Item Name: Crosstube Turning Detail

DART AEROSPACE LTD		Work Order:	125678
Description: Crosstube Assembly		Part Number:	D407-667-245
Inspection Dwg: D407-667-245 Rev: F		Page 1 of 2

DRAWING NO. D407-667-245	TITLE CROSSTUBE ASSY (407 HIGH AFT)	REV. F	DART AEROSPACE LTD ENGINEERING ORDER		D.E.O. NO. D407-667-245-F-1	SHEET NO. SHEET 1 OF 2	SCALE NTS
DRAWN	CHECKED	MFG. APPR.	APPROVED		DE APPR.		
DATE 11.04.08	DATE 11.04.12	DATE 11.04.12	DATE 11.04.12		DATE 11.04.12

DRAWING NO. D407-667-245	TITLE CROSSTUBE ASS'Y (407 HIGH AFT)	REV. F	DART AEROSPACE LTD ENGINEERING ORDER		D.E.O. NO. D407-667-245-F-2	SHEET NO. SHEET 1 OF 1	SCALE NTS
DRAWN 97	CHECKED ASS	MFG. APPR. E	APPROVED MP		DE APPR. H		
DATE 11.09.07	DATE 11.09.19	DATE 11.09.19	DATE 11.09.19		DATE 11.09.19

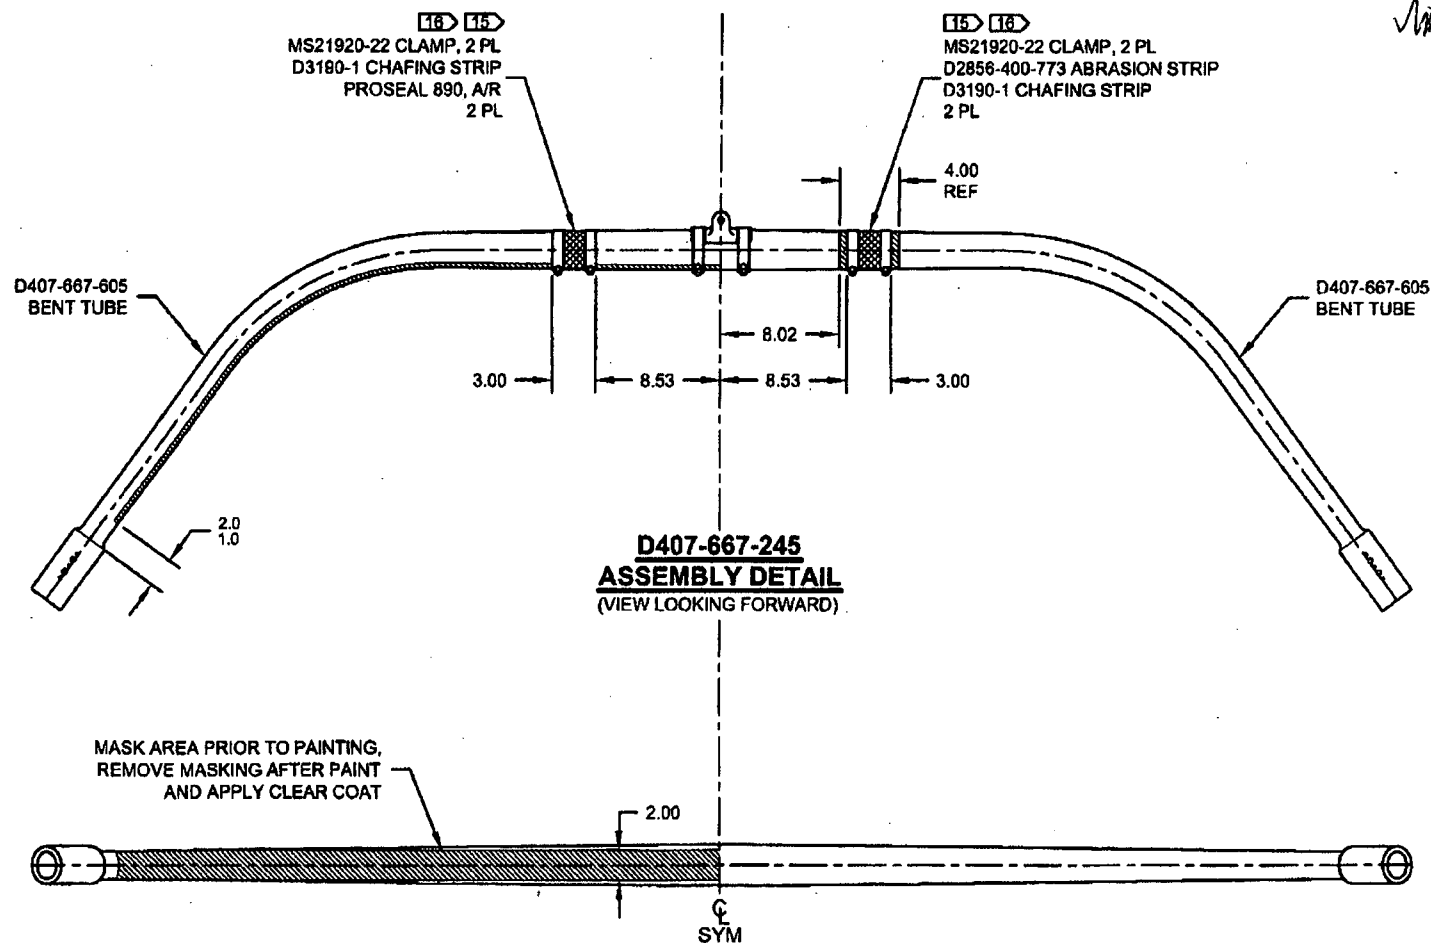
REMOVED ABRASION STRIP IN FAVOR OF A THIN LAYER OF PROSEAL 890.

- 2) FINISH: CHEMICAL CONVERSION COAT PER DART QSI 005 4.1
PRIME INSIDE AND OUTSIDE PER DART QSI 005 4.2
MASK UNDERSIDE OF CROSSTUBE AS SHOWN (HATCHED AREA) AND
PAINT OUTSIDE PER DART QSI 005 4.2
REMOVE MASKING AND APPLY CLEAR COAT
- 15) APPLY A THIN COAT OF PROSEAL 890 ON INSIDE CONCAVE SURFACE OF D3190-1
CHAFING SHIELDS AND LET CURE PER MANUFACTURER'S INSTRUCTIONS. INSTALL
PROSEALED D3190-1 CHAFING SHIELDS ONTO CROSSTUBE BY APPLYING A THIN COAT
OF PROSEAL 890 ONTO CROSSTUBE. BE SURE TO ELIMINATE ANY AIR GAPS.
